Access Compliance Report Public Rights-of-Way (Curb Ramps)

Main Street: PARKVIEW_TE		Cross Street: CHARMAINE_LN		Location:	NW
ADA ID: RPRK211006171252	Ramp Type:Type 1 - Perpendicular Diagonal Initial Pass/Fail: Fail		Overall Compliance: No	Severity Score:	45

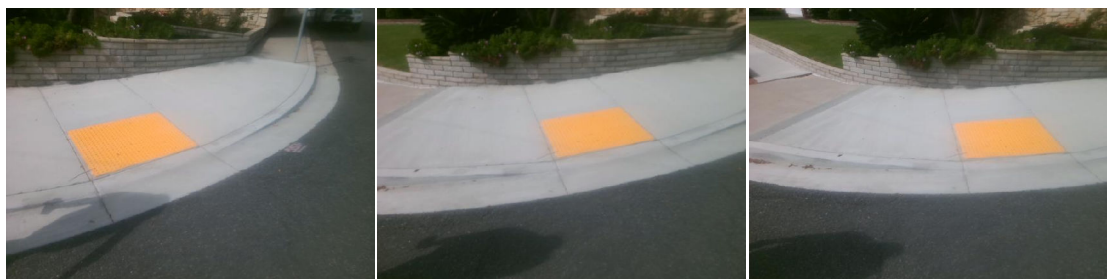
R304.2.2, R204.3, R304.5.3, STD 1115

Remove & Replace Curb Ramp With Two New Directional Ramps or Equivalent.
